10/13/95	ADDENDUM 1
DATE	REVISION
STATE OF HAWAII DEPARTMENT OF TRANSPORTATION HIGHWAYS DIVISION ROOF WALKWAYS COMMON WORK H-3 FINISH (UNIT III) FAIP NO. I-H3-1(75), UNIT III T.K. TUNNEL/ACCESS ROADS SCALE: 1" = 20' DATE: JUN 1995	
SHEET NO. 7A1	OF 5 SHEETS

STATE OF HAWAII
DEPARTMENT OF TRANSPORTATION
HIGHWAYS DIVISION
**ACCESS OPENING SAFETY
RAILING — HALAWA**
COMMON WORK
H-3 FINISH (UNIT III)
FAIP NO. I-H3-I(75), UNIT III
T.K. TUNNEL/ACCESS ROADS
SCALE: NONE
DATE: JUN 1995
SHEET NO. 7SI OF 6 SHEETS

POTABLE WATER TANK

WATER TREATMENT AND TANK
ACCESS ROOM PLAN
HALAWA OB PORTAL BLDG-LEVEL 2

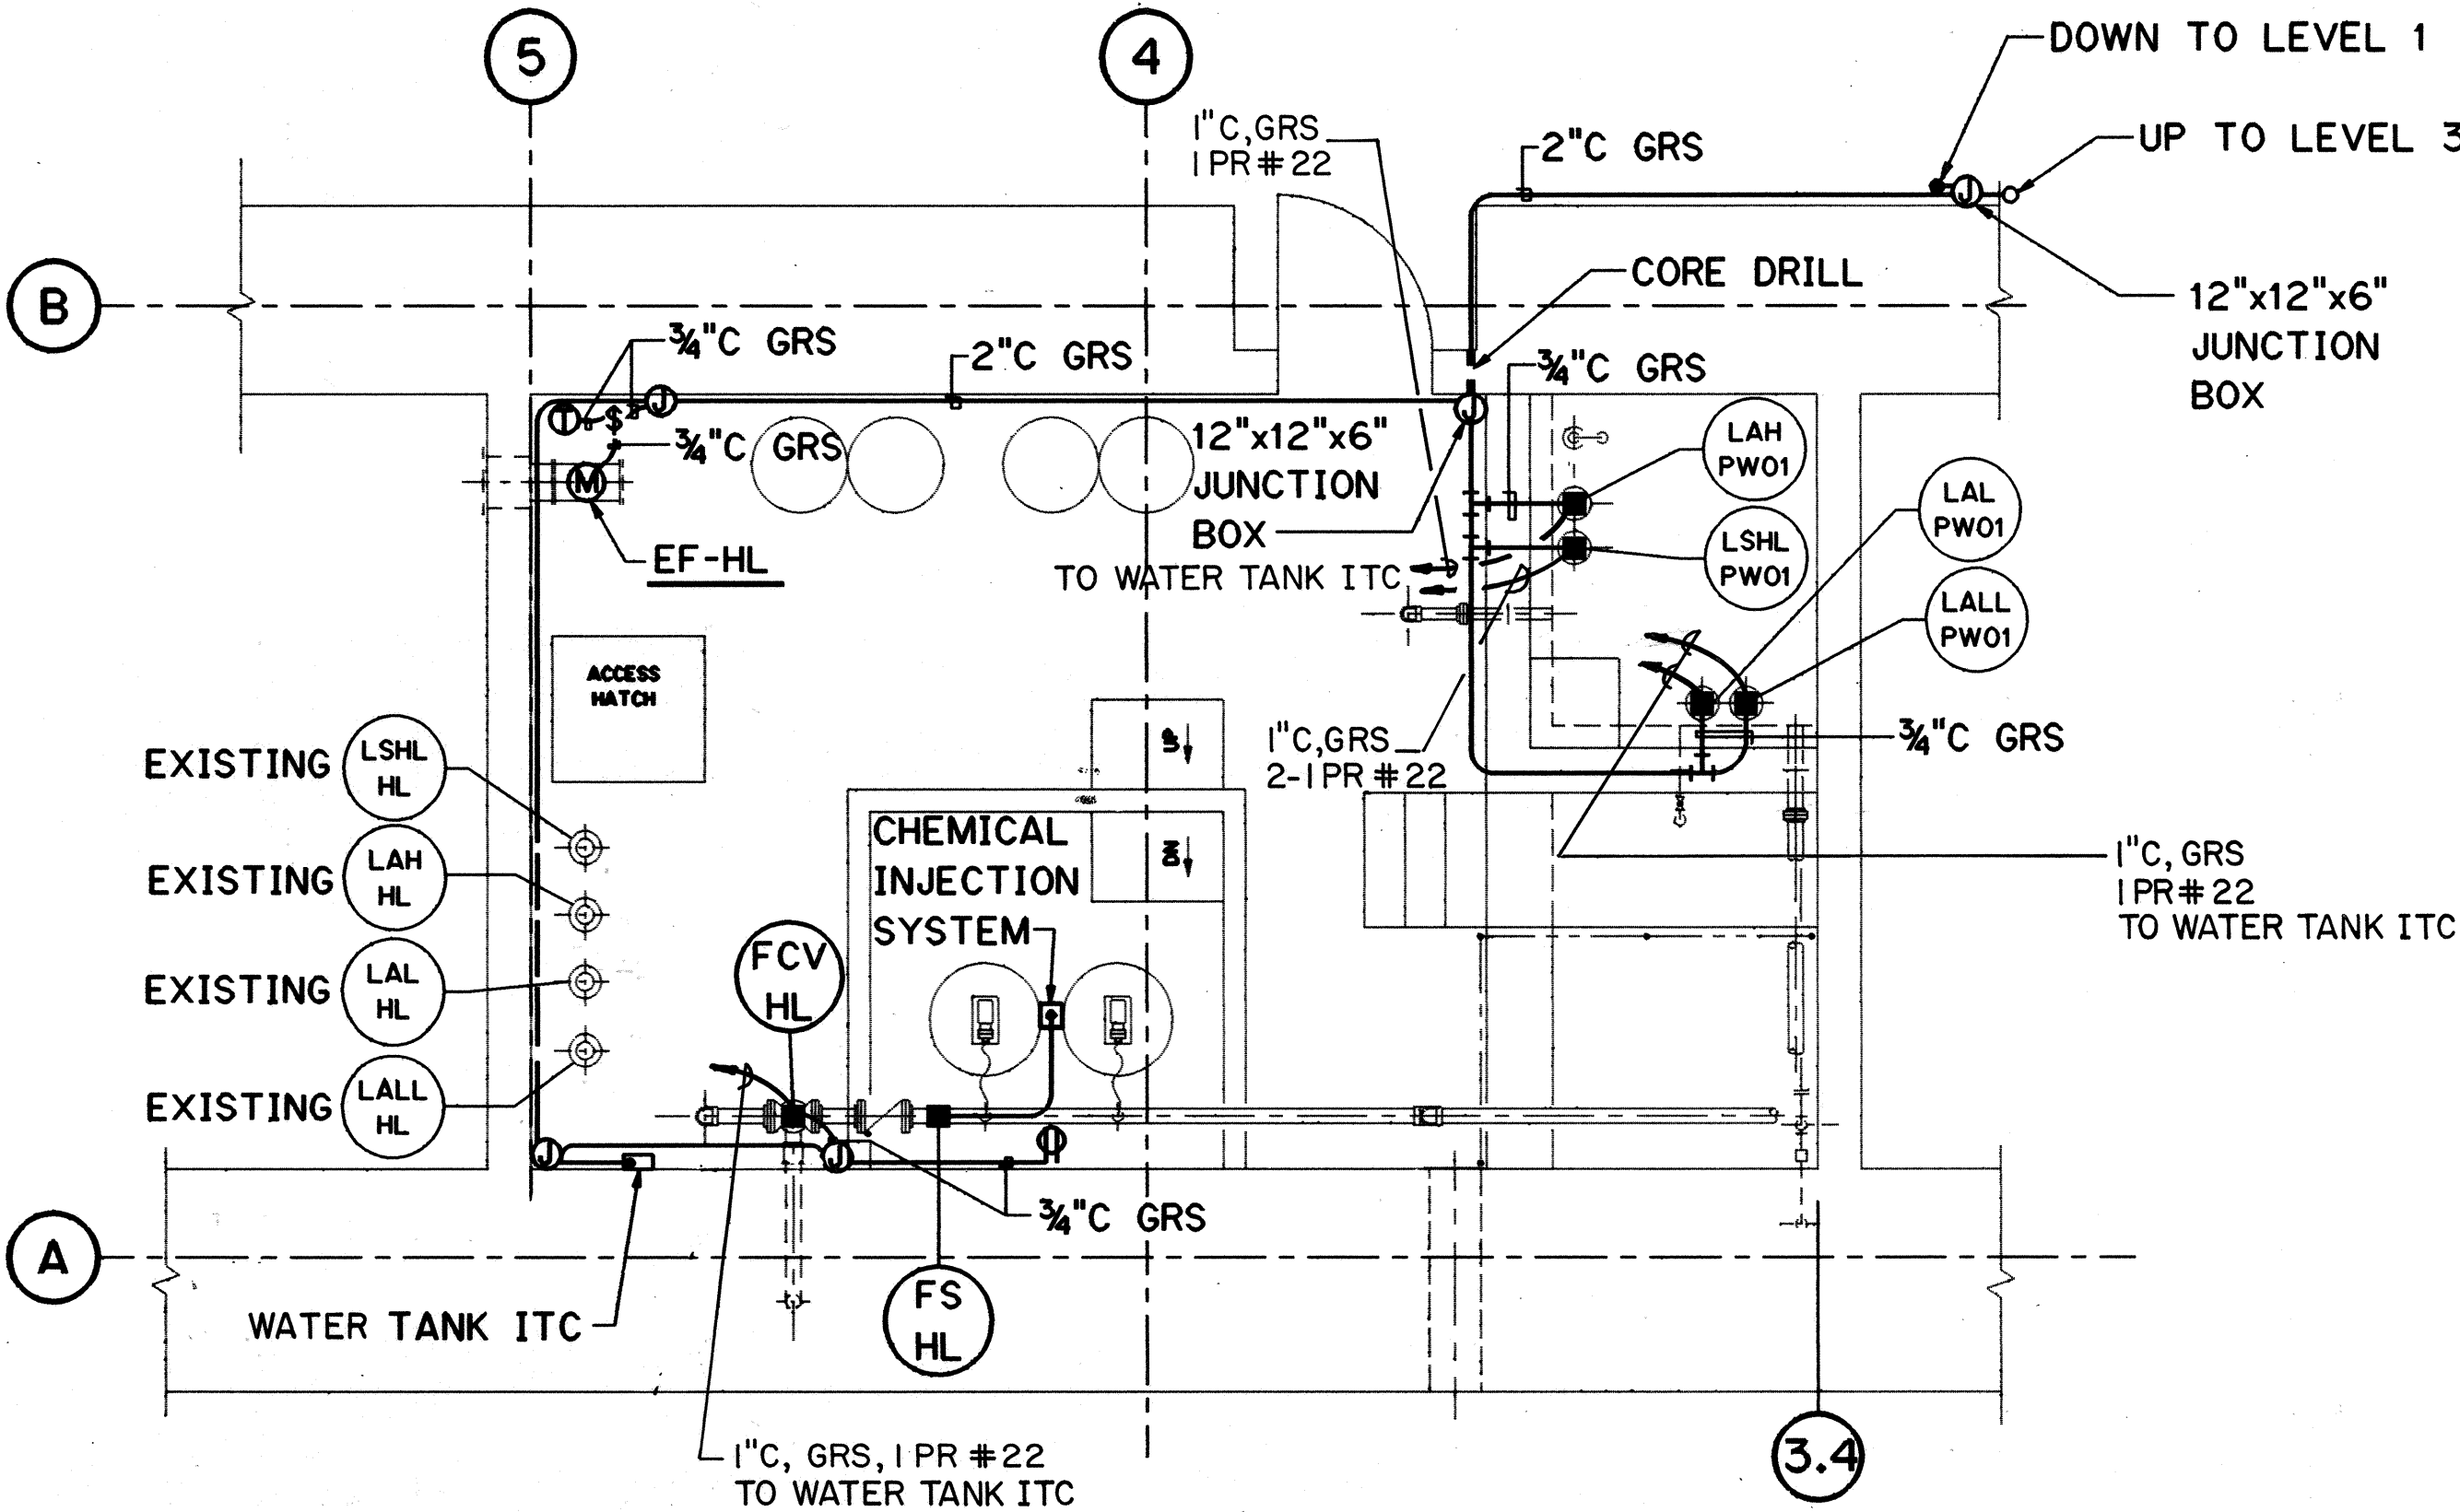
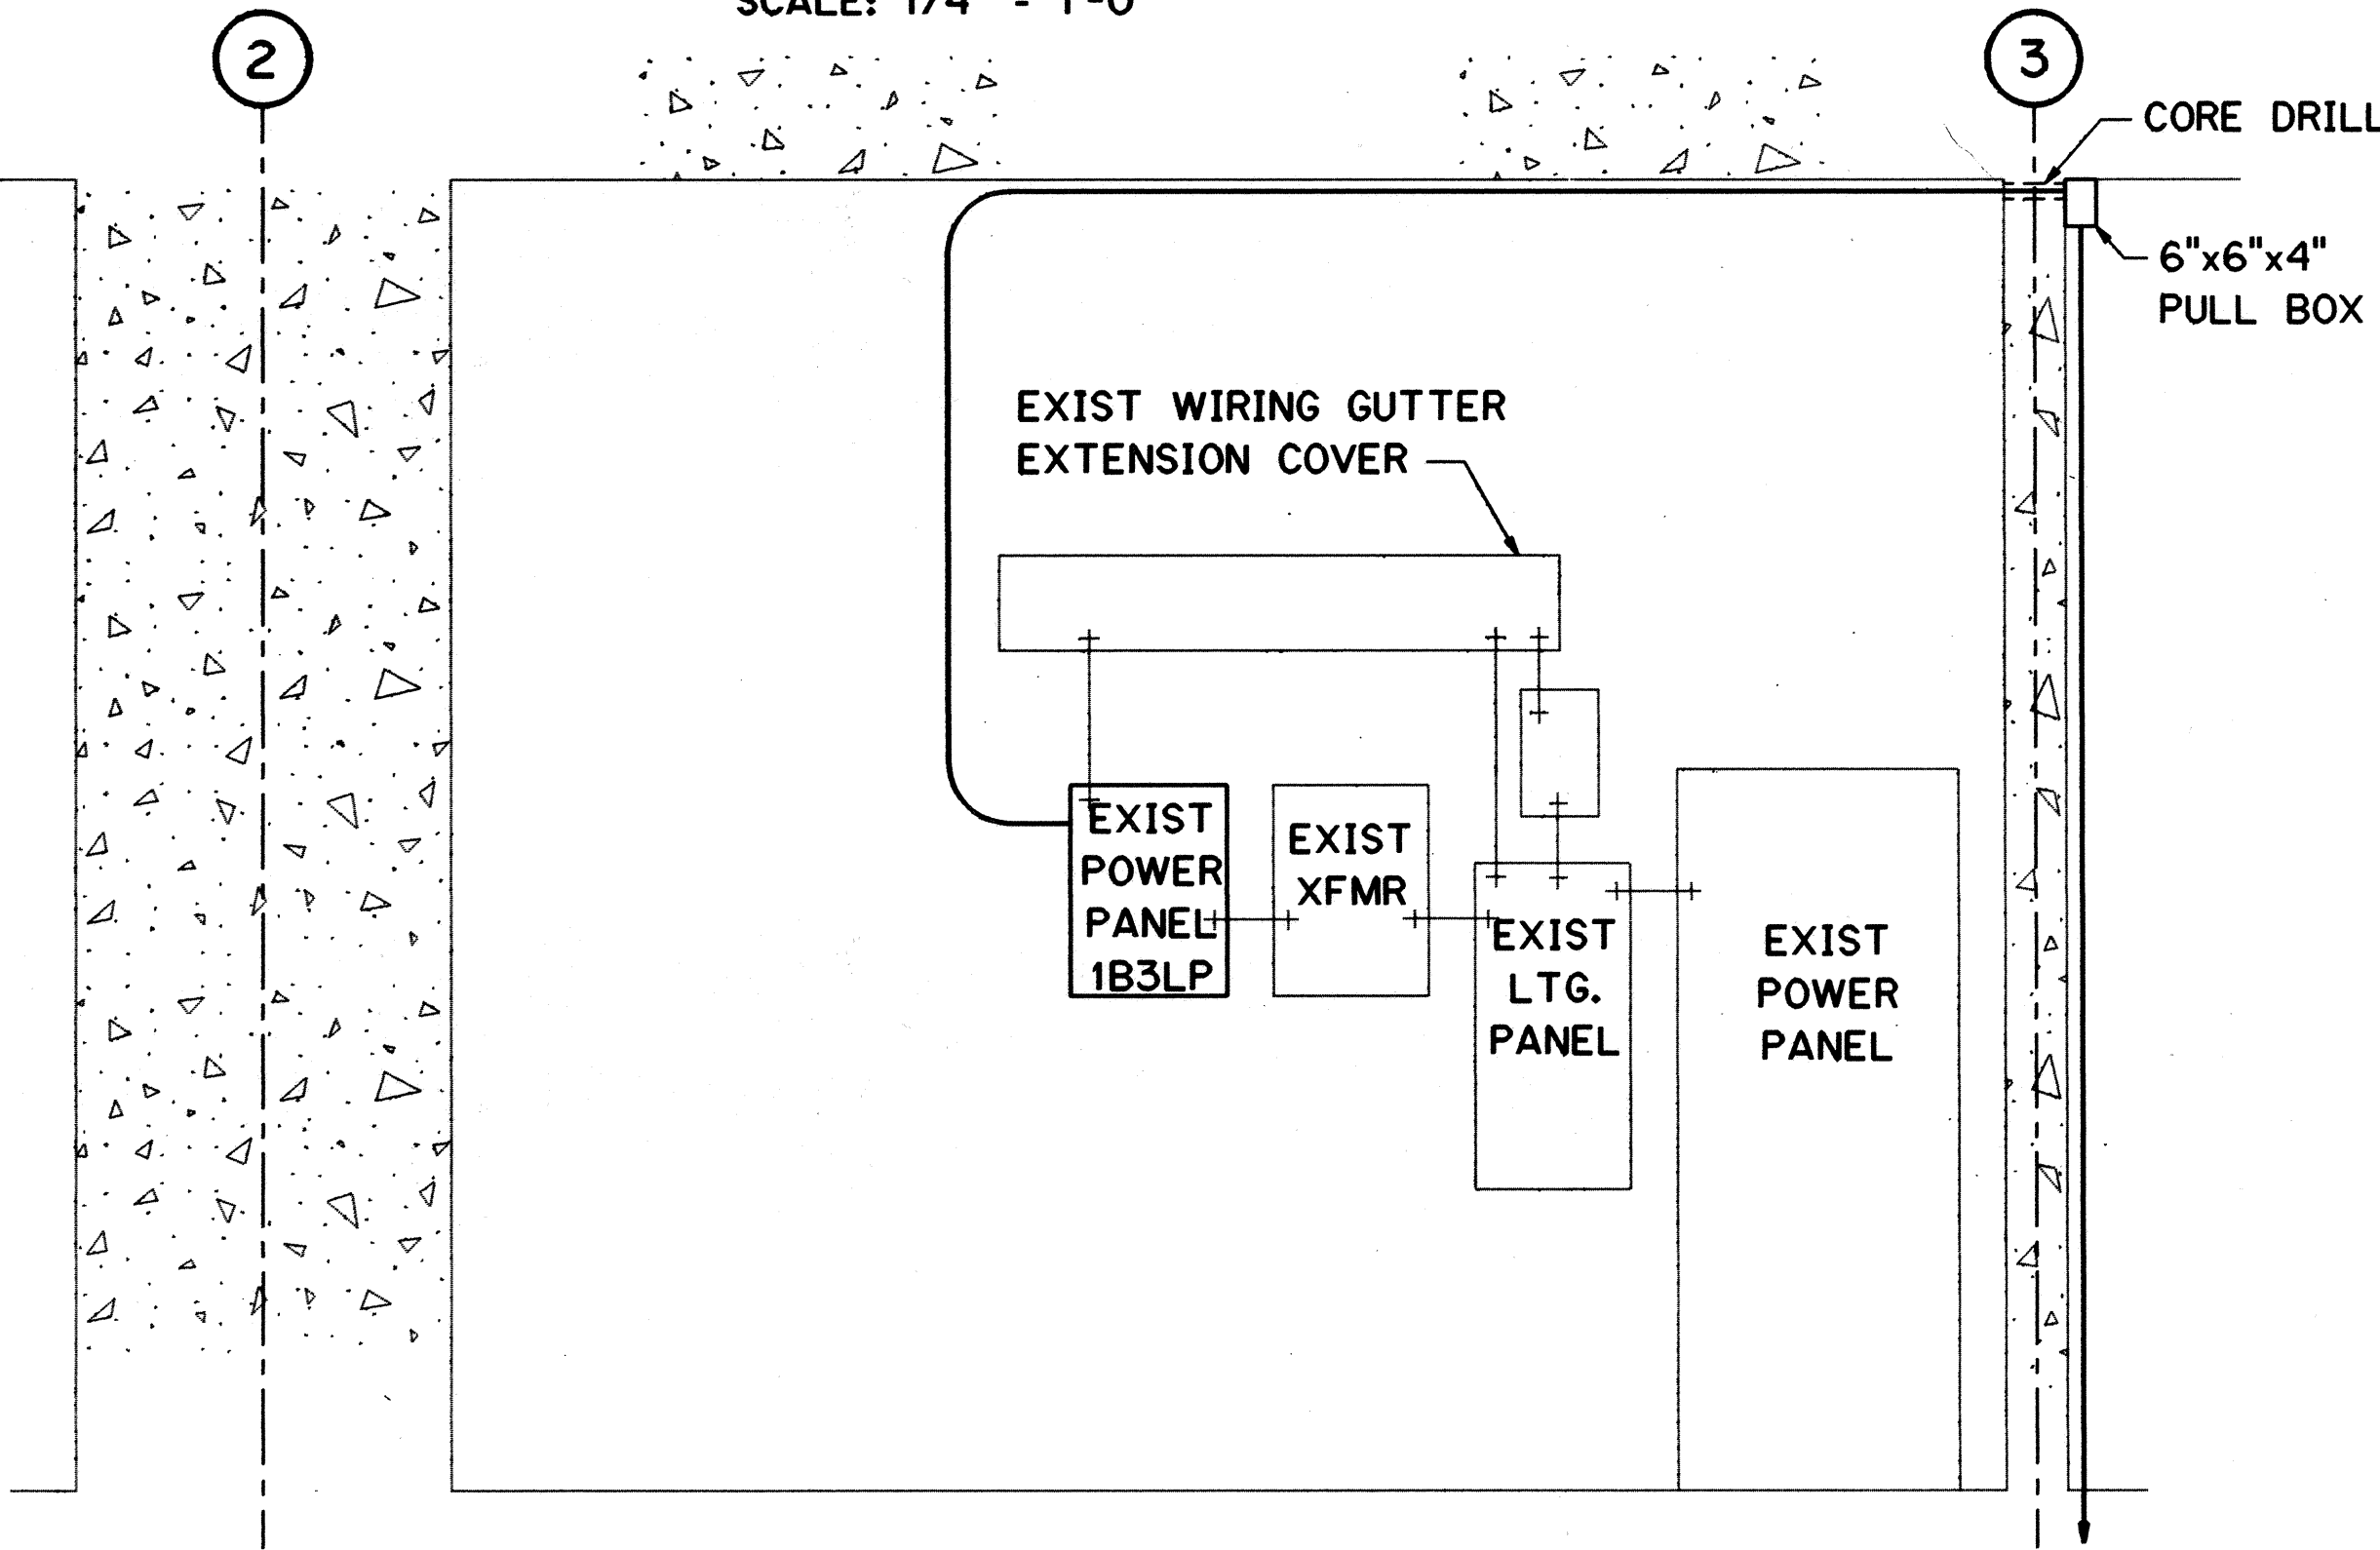
DATE	REVISION
10/27/95	ADDENDUM 2- DELETED POTABLE WATER STOR. TK ITC, ADDED MONITORING CONDUIT
STATE OF HAWAII DEPARTMENT OF TRANSPORTATION HIGHWAYS DIVISION	
HALAWA POTABLE WATER TREATMENT POWER PLAN	
COMMON WORK	
H-3 FINISH (UNIT III)	
FAIP NO. I-H3-1(75), UNIT III	
T.K. TUNNEL/ACCESS ROADS	
SCALE: 1/2" = 1'-0"	DATE: JUN 1995
SHEET NO. 7E1	OF 6 SHEETS
